PROJECT DETAILS 91M 91-93 MCINTOSH ROAD NARRAWEENA NSW 2099 PROJECT NORTH (-)

09.18 DA ISSUE 01 02.19 AMMENDMENTS AS NOTED R AND REISSUED TO COUNCIL С 04.19 AMMENDMENTS AS NOTED AND REISSUED TO COUNCIL

SCALE	PROJECT NO.	DRAWING NO.	DRAWING
1:200 @ A3	1816A	A-0101	BASEMENT FLOOR PLAN

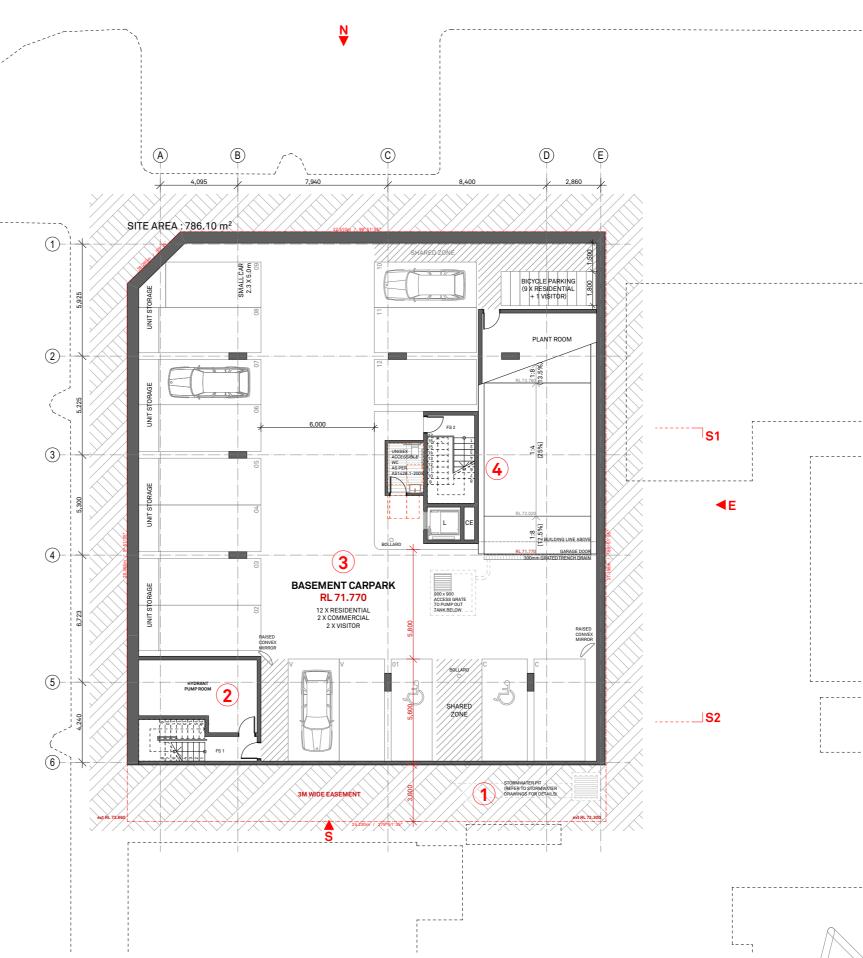
- **1. INCREASED EASEMENT TO SOUTHERN BOUNDARY** FROM 1.5M TO 3M
- 2. RECONFIGURATION OF BASEMENT EGRESS AND ESSENTIAL SERVICES TO ACCOMODATE INCREASED WIDTH IN EASEMENT TO SOUTHERN BOUNDARY
- 3. BASEMENT SLAB LEVEL RAISED 100MM
- 4. MINOR AMENDMENTS TO CORE CONFIGURATION DUE TO EASEMENT AND REDUCTION IN LENGTH OF BASEMENT ACCESS RAMP TO ACCOMODATE RAISED BASEMENT SLAB LEVEL

SCALE	PROJECT NO.	DRAWING NO.	DRAWING
1:200 @ A3	1816A	A-0102	GROUND FLOOR PLAN

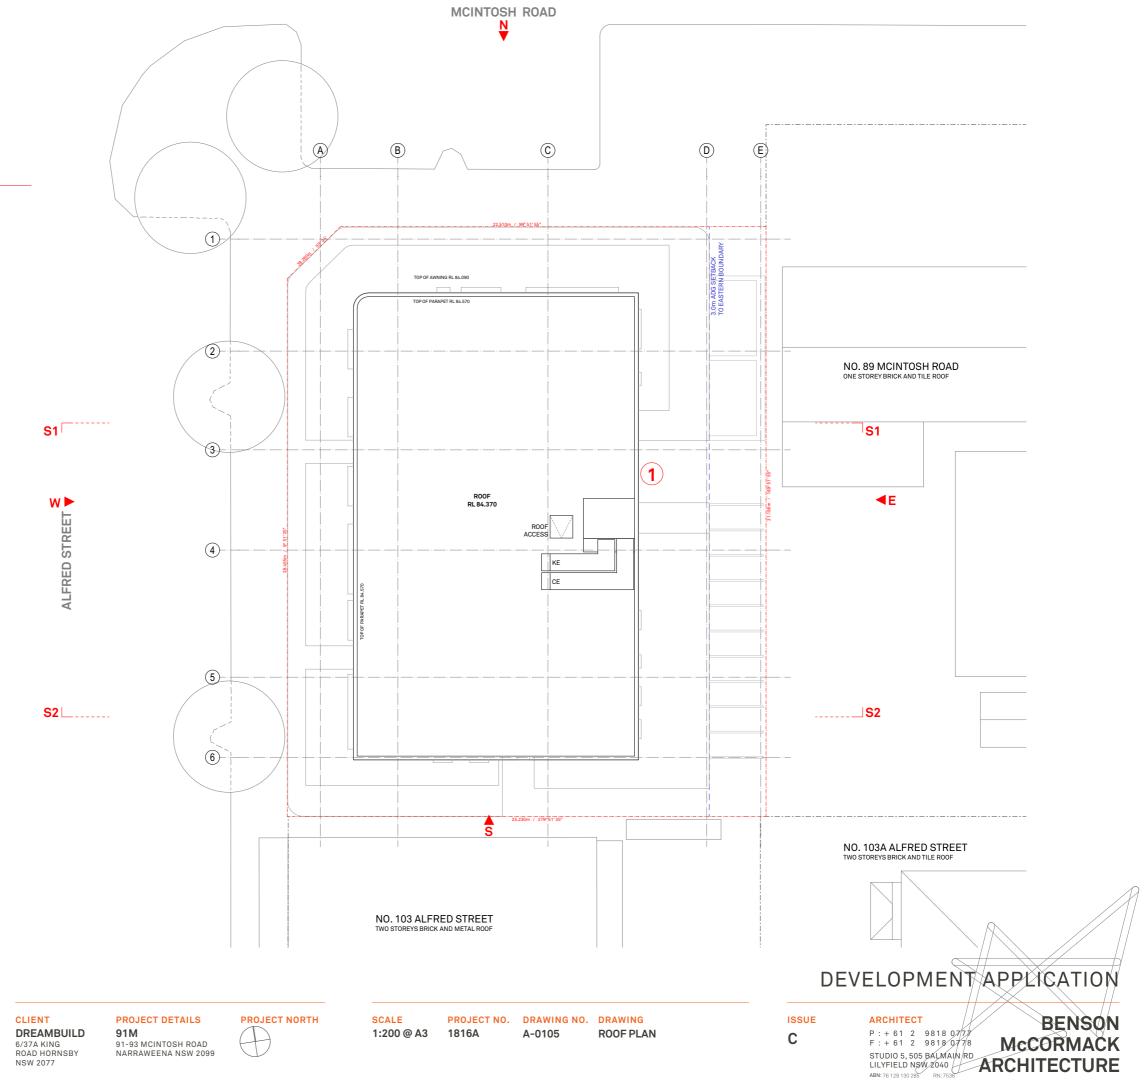
- 1. SHOPFRONTS AMENDED TO ACCOMODATE FUTURE TENANT REQUIREMENTS
- 2. ACCESS RAMP TO ELEVATED WALKWAY ADJUSTED TO SUIT NEW SHOPFRONT ARRANGEMENT
- 3. AMENDMENTS TO BOUNDARY STRUCTURE AND ROOF OVER DRIVEWAY
- 4. INCREASED EASEMENT TO SOUTHERN BOUNDARY FROM 1.5M TO 3M
- 5. GROUND FLOOR RETAIL, COMMERIAL UNITS AND RESIDENTIAL LOBBY AMENDMENTS TO ACCOMODATE INCREASED EASEMENT TO SOUTHERN BOUNDARY
- 6. MINOR AMENDMENTS TO CORE CONFIGURATION

PROJECT NO. DRAWING NO. DRAWING 1816A A-0201 MCINTOSH RD ELEVATION

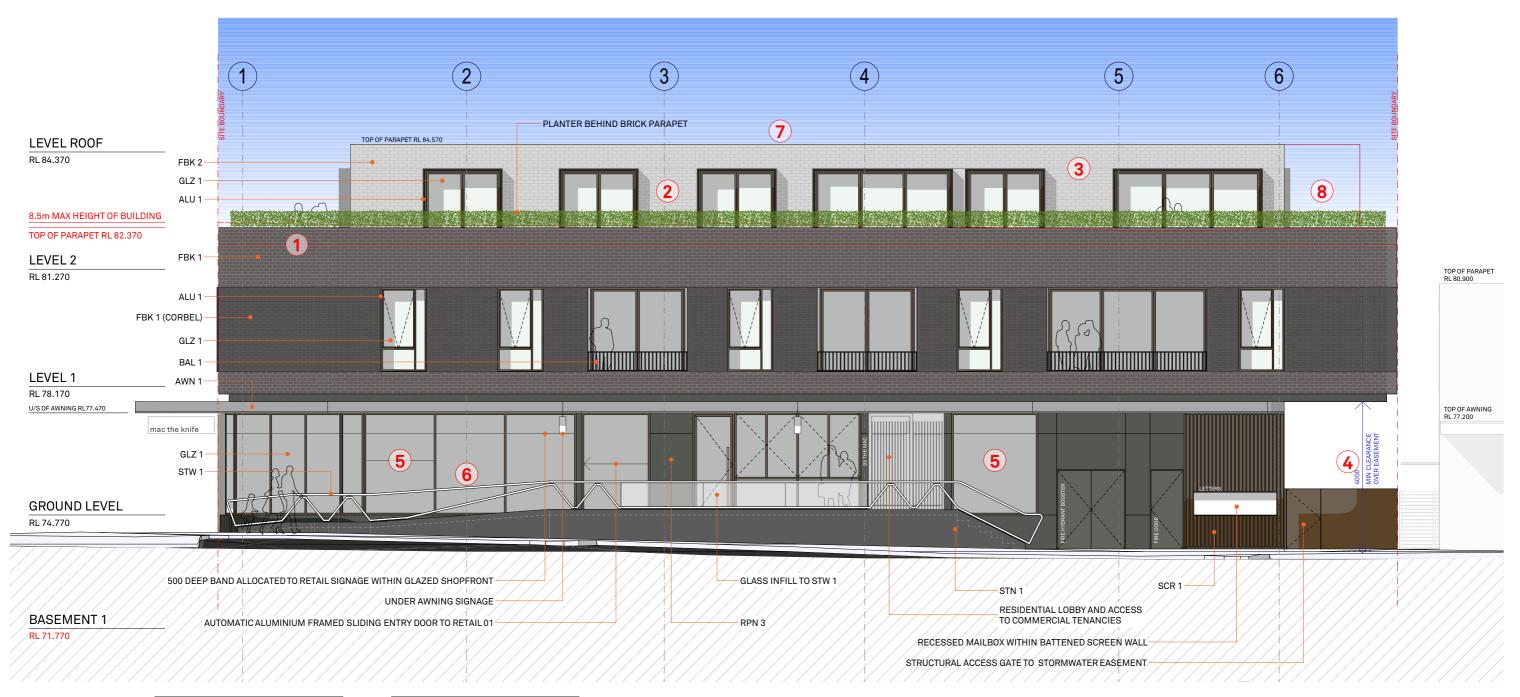
- 1. BRICK PARAPET RAISED TO 1100MM ABOVE TERRACE AT LEVEL 2
- 2. EXTERNAL ALUMINIUM SURROUNDS ADDED TO OPENINGS AT LEVEL 2
- **3. CONTINIOUS AWNING TO LEVEL 2 REMOVED**
- 4. SHOPFRONT AMENDMENTS TO ACCOMODATE TENANT REQUIREMENTS
- 5. HANDRAIL TO RAISED SHOPFRONT ACCESS AMENDED
- 6. ROOF OVER DRIVEWAY ACCESS REMOVED
- 7. WINDOW TO ENSUITE OF UNIT 07 ADDED
- 8. FACE BRICK ADDED TO LEVEL 2. REFER REVISED FINISHES SCHEDULE

SCALE PROJECT NO. DRAWING NO. DRAWING 1:100 @ A3 1816A A-0202 ALFRED ST ELEVATION

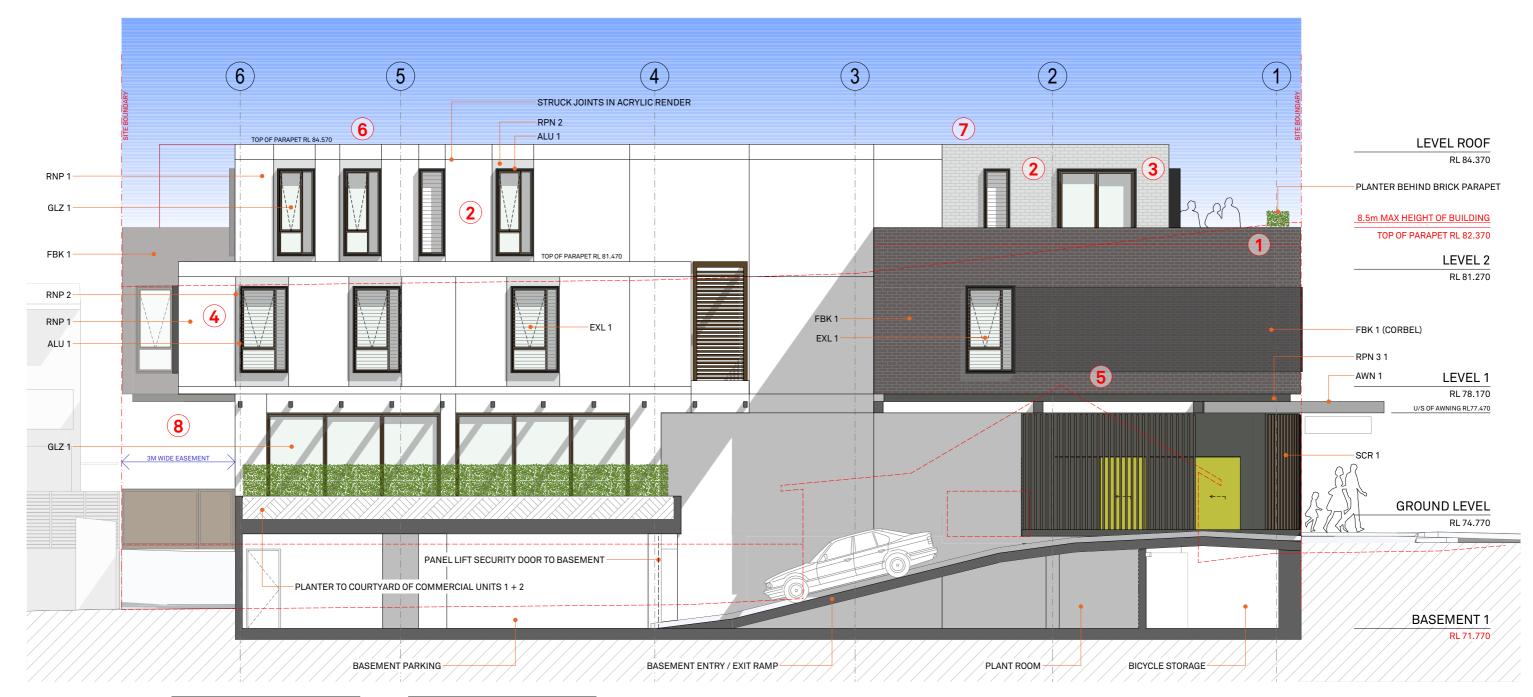
- 1. BRICK PARAPET RAISED TO 1100MM ABOVE TERRACE AT LEVEL 2
- 2. EXTERNAL ALUMINIUM SURROUNDS ADDED TO OPENINGS AT LEVEL 2
- **3. CONTINIOUS AWNING TO LEVEL 2 REMOVED**
- 4. EASEMENT TO SOUTHERN BOUNDARY INCREASED IN WIDTH TO 3M STRUCTURAL ACCESS GATE TO EASEMENT ADDED
- 5. SHOPFRONT AMENDMENTS TO ACCOMODATE TENANT REQUIREMENTS AND INCREASED WIDTH OF EASEMENT TO SOUTHERN BOUNDARY
- 6. HANDRAIL TO RAISED SHOPFRONT ACCESS AMENDED
- 7. FACEBRICK ADDED TO LEVEL 2. REFER REVISED FINISHES SCHEDULE
- 8. INCREASED SETBACK TO LEVEL 2

SCALE PROJECT NO. DRAWING NO. DRAWING 1:100 @ A3 1816A A-0203 EAST ELEVATION

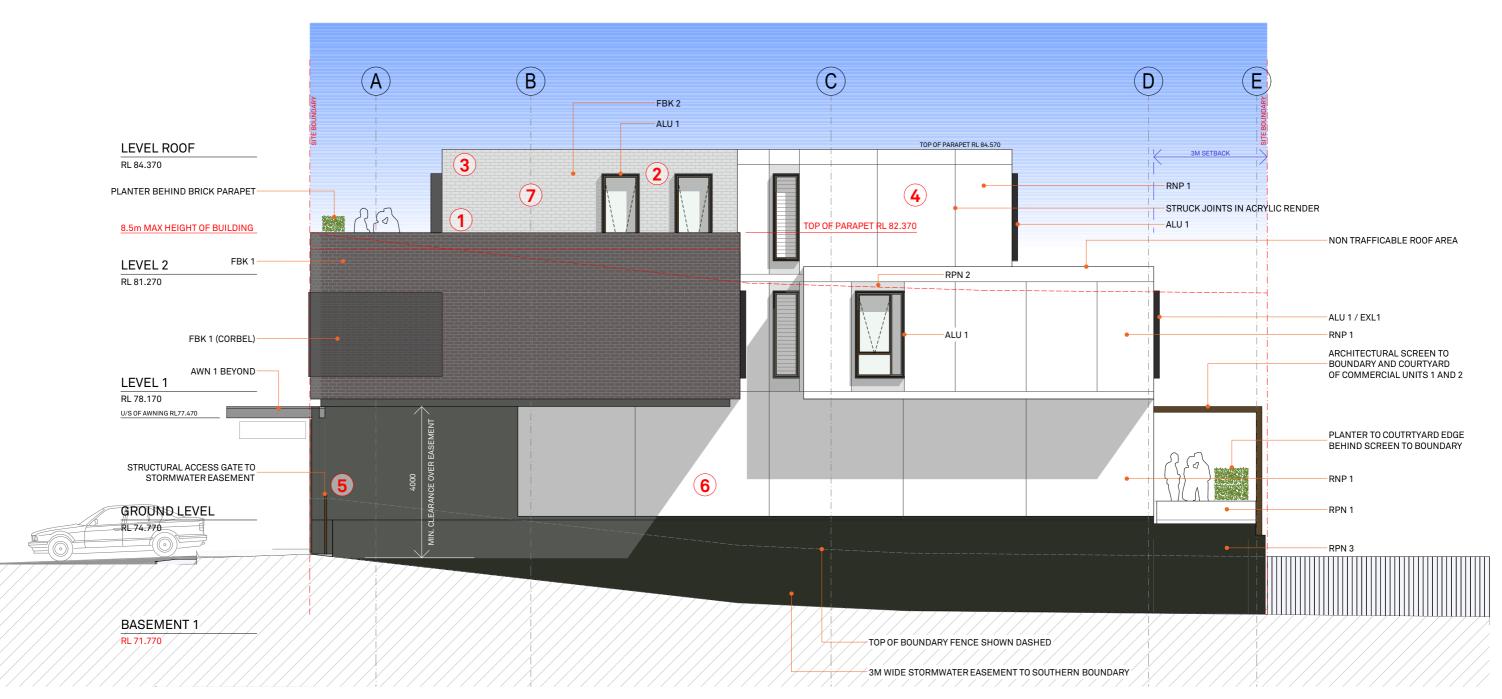
- 1. BRICK PARAPET RAISED TO 1100MM ABOVE TERRACE AT LEVEL 2
- 2. EXTERNAL ALUMINIUM SURROUNDS ADDED TO OPENINGS AT LEVEL 2
- **3. CONTINIOUS AWNING TO LEVEL 2 REMOVED**
- 4.2 X COLOURED ACRYLIC RENDERS ADDED. RENDER TO HAVE STRUCK JOINTS AS INDICATED.
- 5. ROOF OVER DRIVEWAY ACCESS REMOVED
- 6. MINOR AMENDMENTS TO EXTERNAL OPENINGS TO ACCOMODATE INTERNAL PLANNIGN CHANGES TO UNIT 09
- 7. FACEBRICK ADDED TO LEVEL 2. REFER TO REVISED FINISHES SCHEDULE
- 8. EASEMENT TO SOUTHERN BOUNDARY INCREASED TO 3M IN WIDTH
